UNITED STATES
DEPARTMENT OF THE INTERIOR
BUREAU OF LAND MANAGEMENT

SUNDRY NOTICES AND REPORTS ON WELLS
Do not use this form for proposals to drill or to re-enter an abandoned well. Use Form 3160-3 (APD) for such proposals.

Mewbourne Oil Company requests approval to make the following changes to the approved APD (10400089149, 30-025-53218):

PECOS DISTRICT DRILLING CONDITIONS OF APPROVAL

Figure 1. Cactus 13 3/8" 5M offline cementing tool. Pressure rating limited by the lesser of 5M tool rating or the 13 3/8" pup joint and casing.

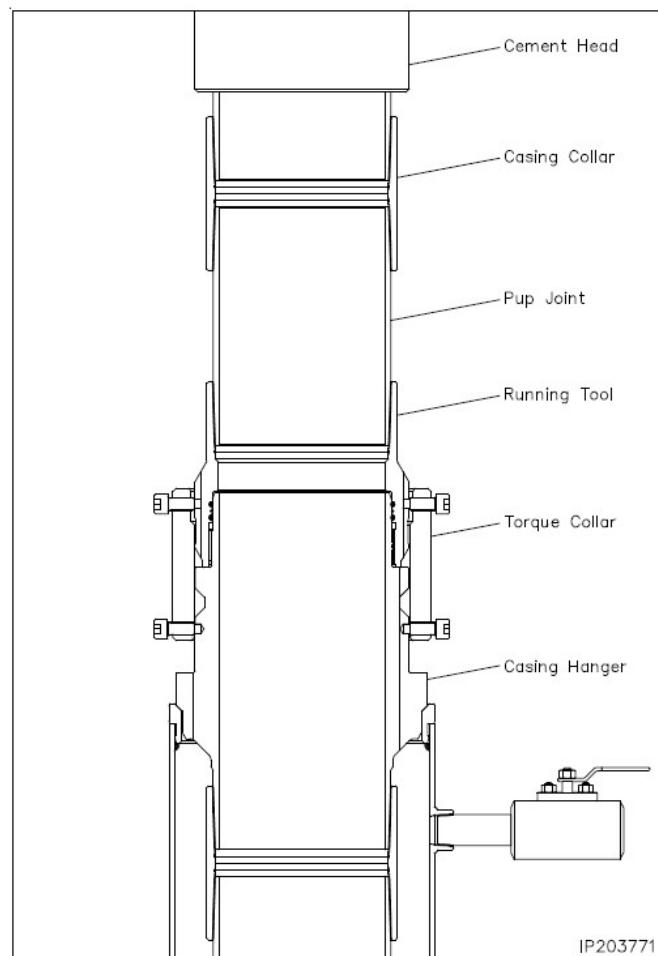
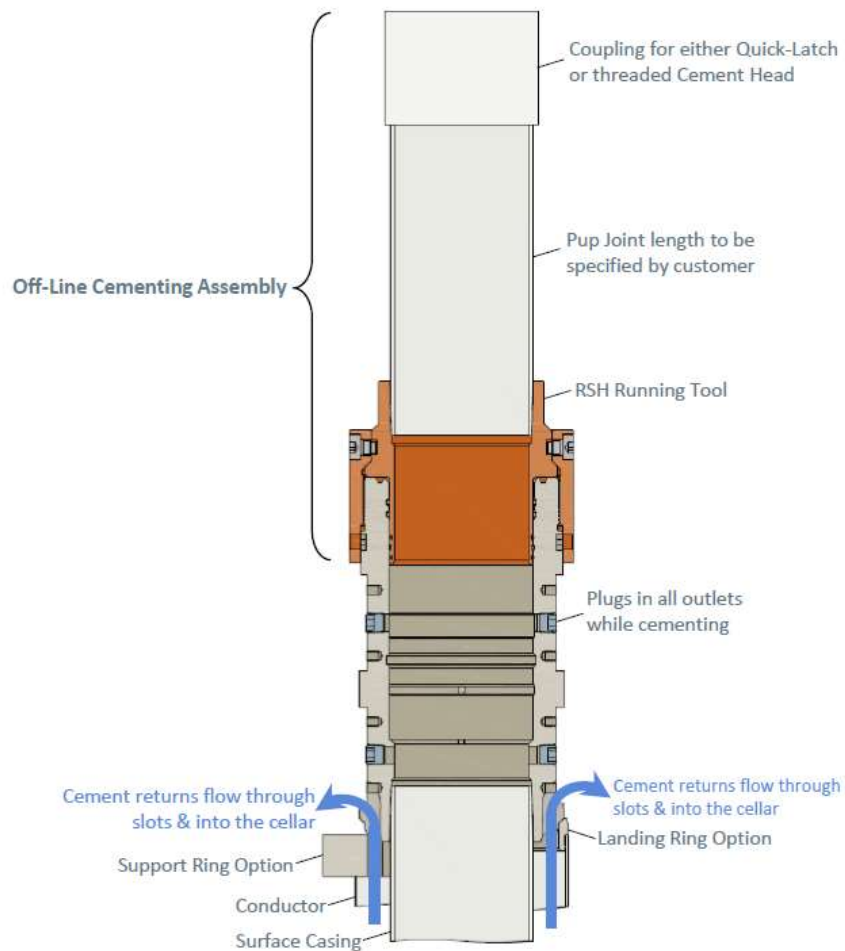
9. Make up offline cement tool with forklift per wellhead manufacturer (Fig. 1 & 2).
10. Make up cement head on top of offline cement tool with forklift.

Figure 3. Cactus 9 5/8" 5M offline cementing tool. Pressure rating limited by the lesser of 5M tool rating or the 9 5/8" pup joint and casing.

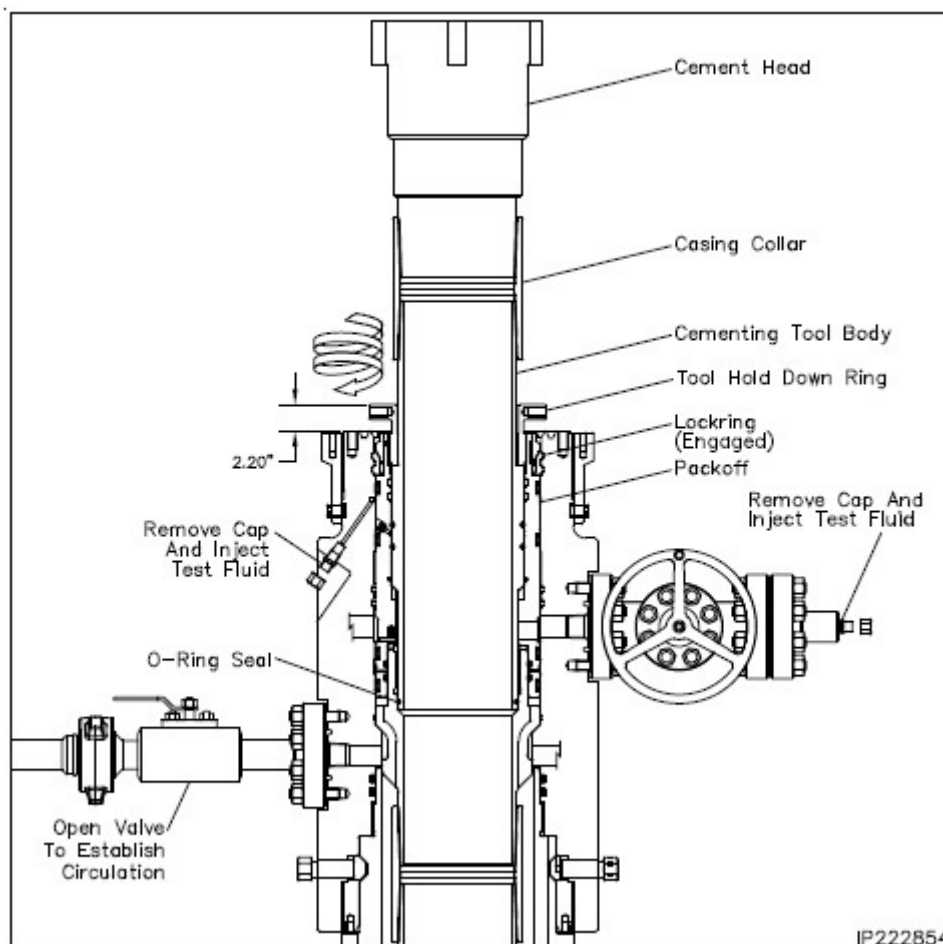
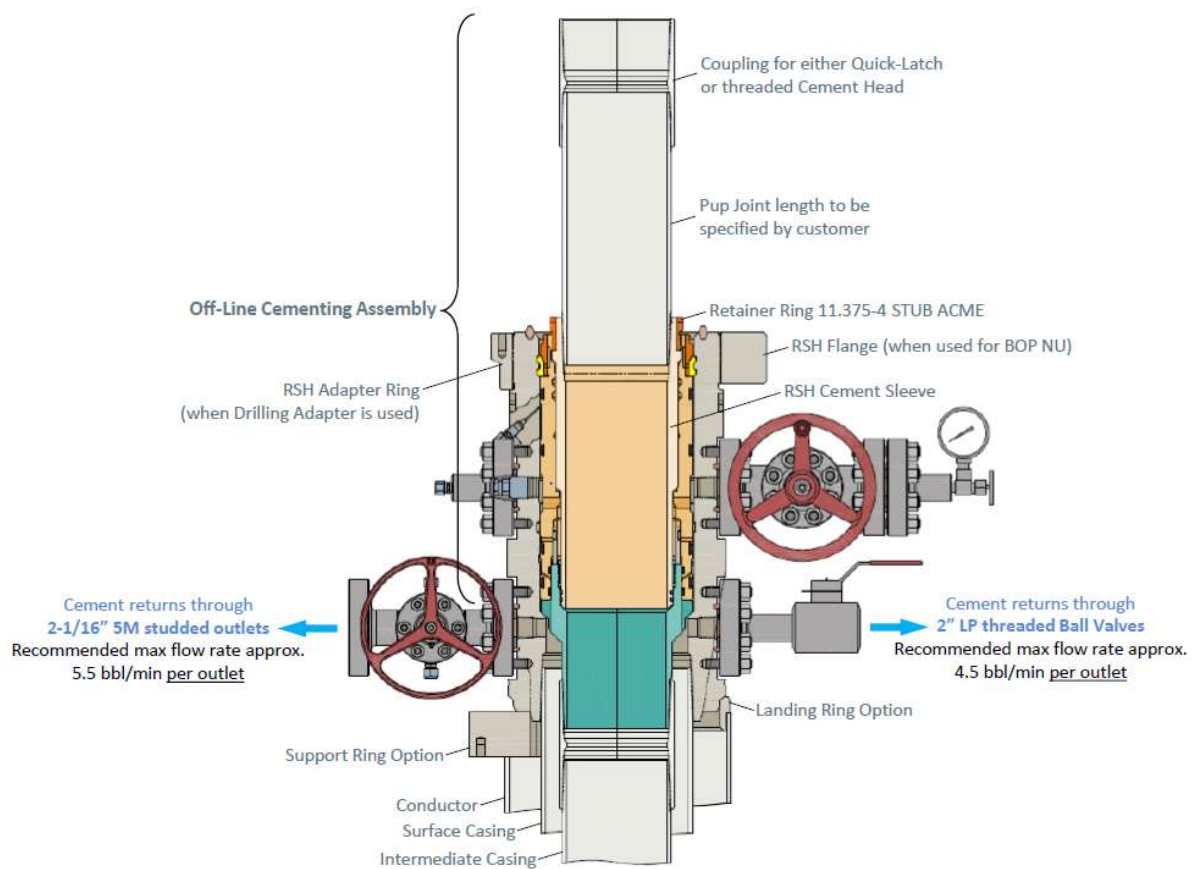
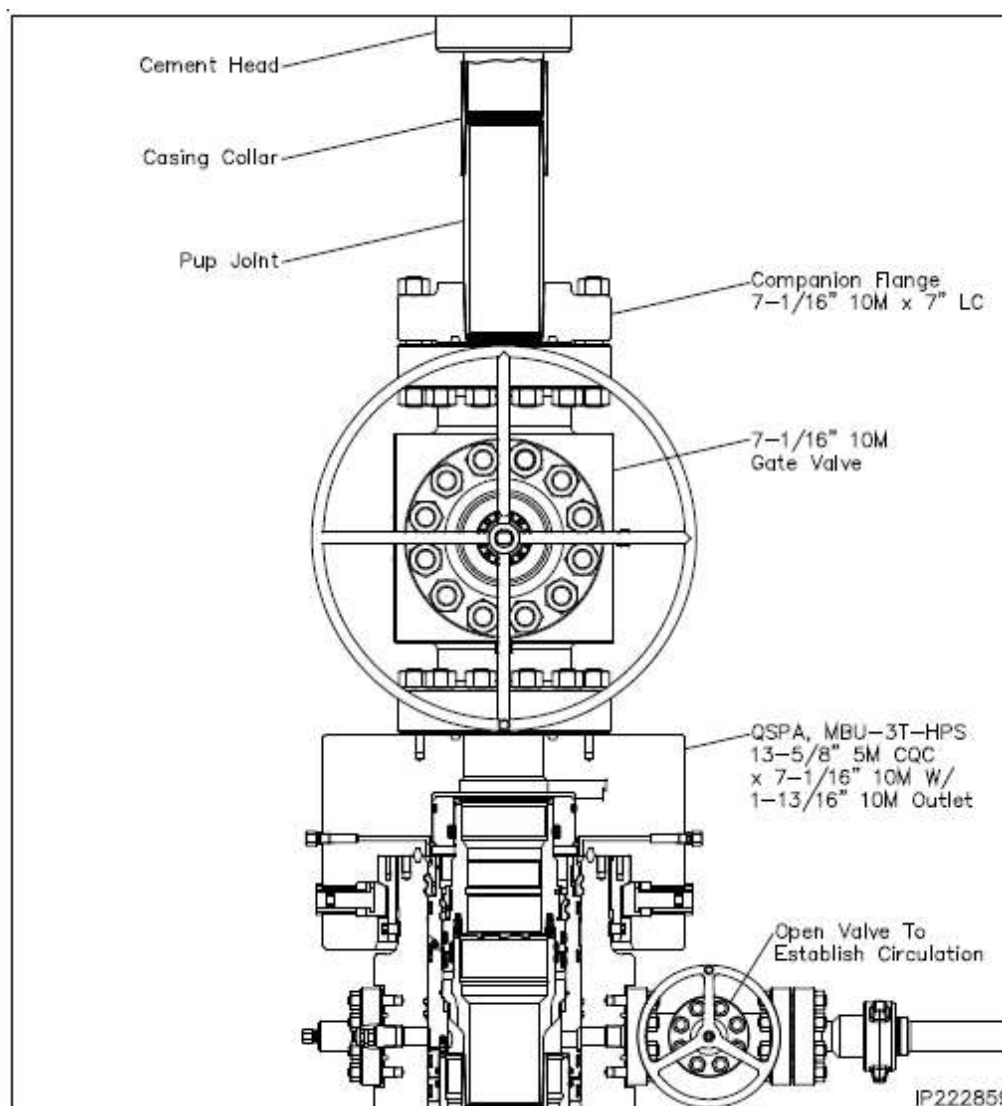
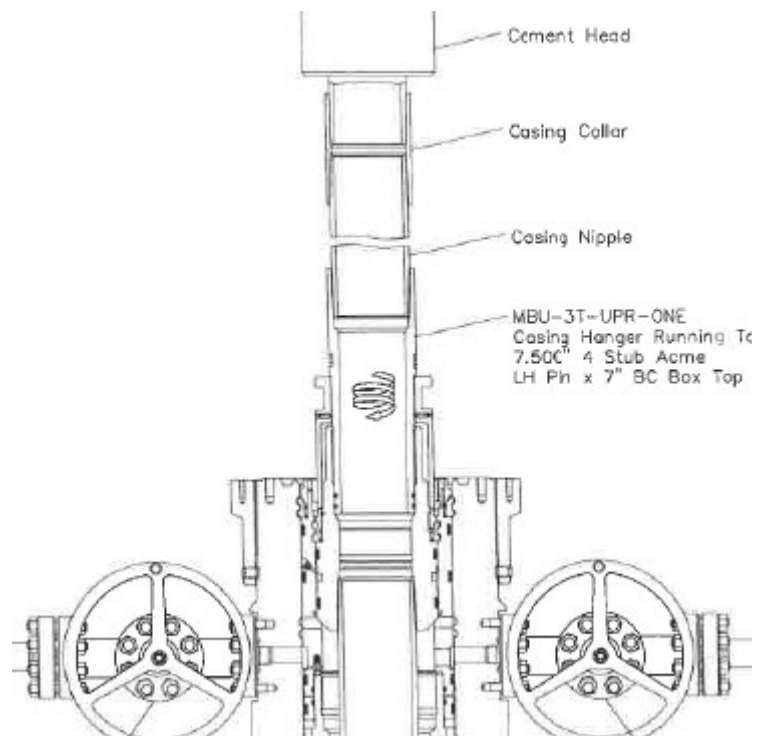
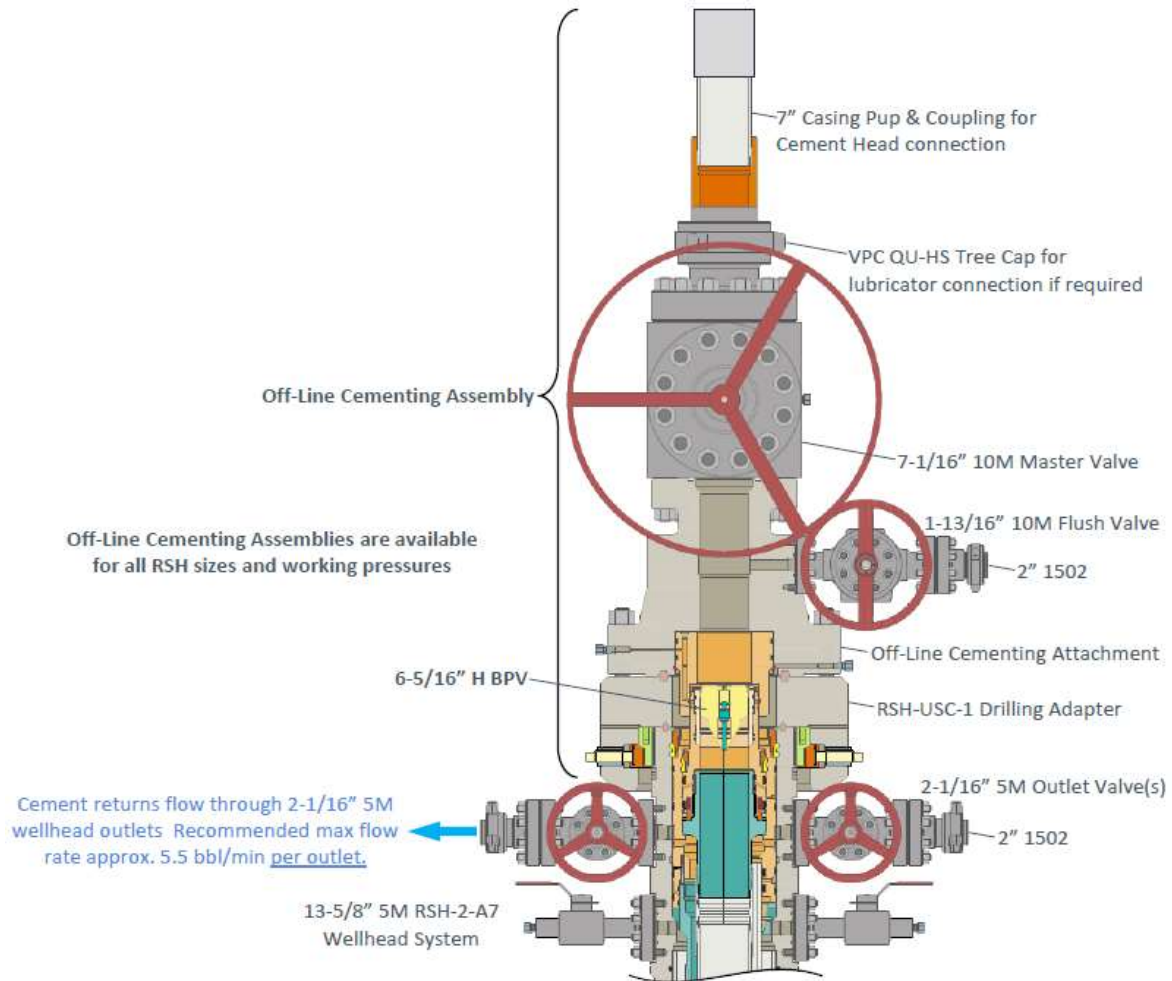
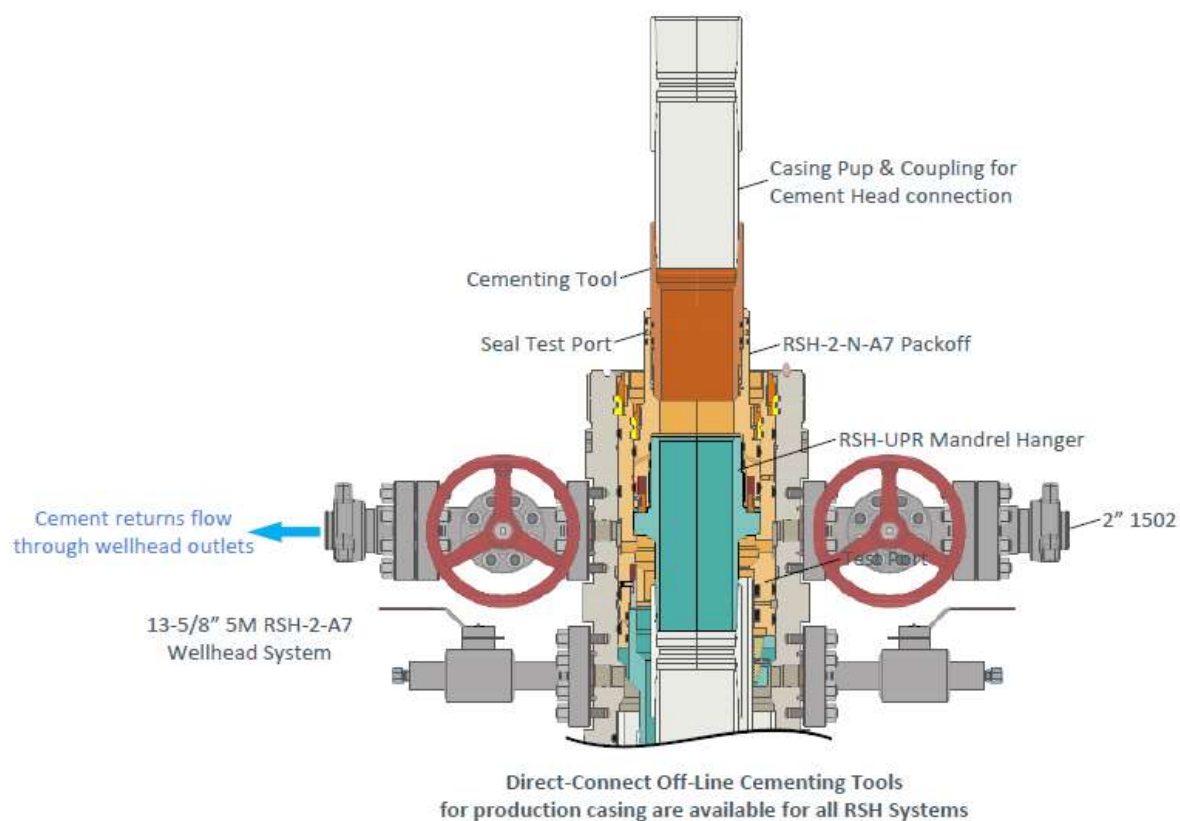
10. Make up offline cement tool using forklift per wellhead manufacturer (Fig. 3 - 8).
11. Make up cement head on top of offline cement tool.
12. Commence cement operations.

Figure 1. BOP diagram

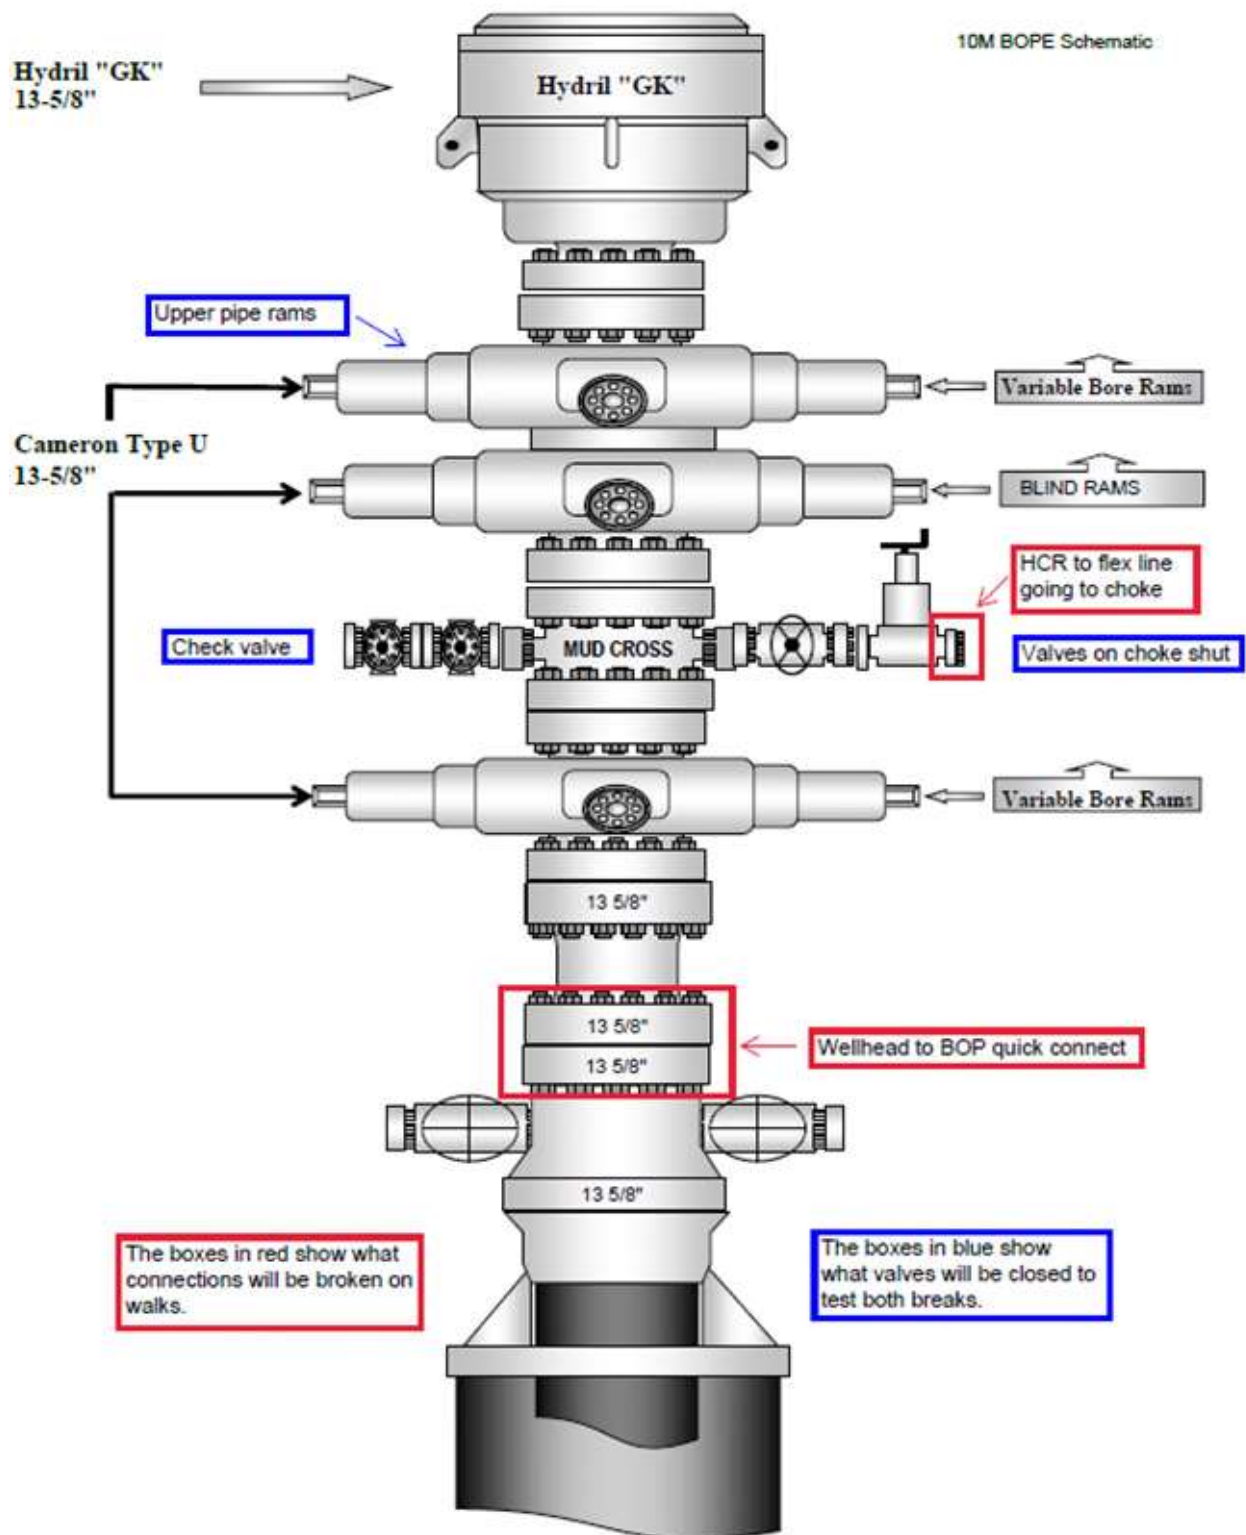
2. After the well section is secured and the well is confirmed to be static, the BOP will be disconnected from the wellhead and walked with the rig to another well on the pad. Two breaks on the BOPE will be made (Fig. 1).

9. A test will then be conducted against the upper pipe rams and choke, testing both breaks (Fig. 1 & 2).
10. The test will be held at 250 psi low and to the high value submitted in the APD, not to exceed 5000 psi.

Figure 5. Cactus 5M wellhead with BOP quick connect

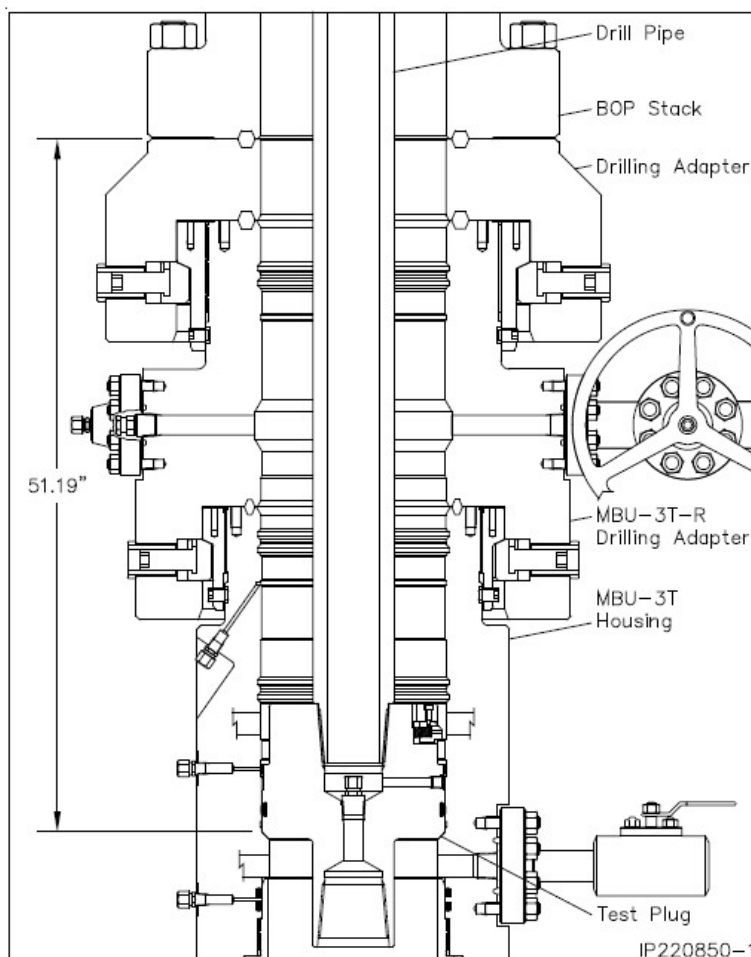
- Connection between the flex line and the HCR valve
 - Connection between the wellhead and the BOP quick connect (Fig. 5 & 6).
3. A capping flange will be installed after cementing per wellhead vendor procedure & casing pressure will be monitored via wellhead valve.
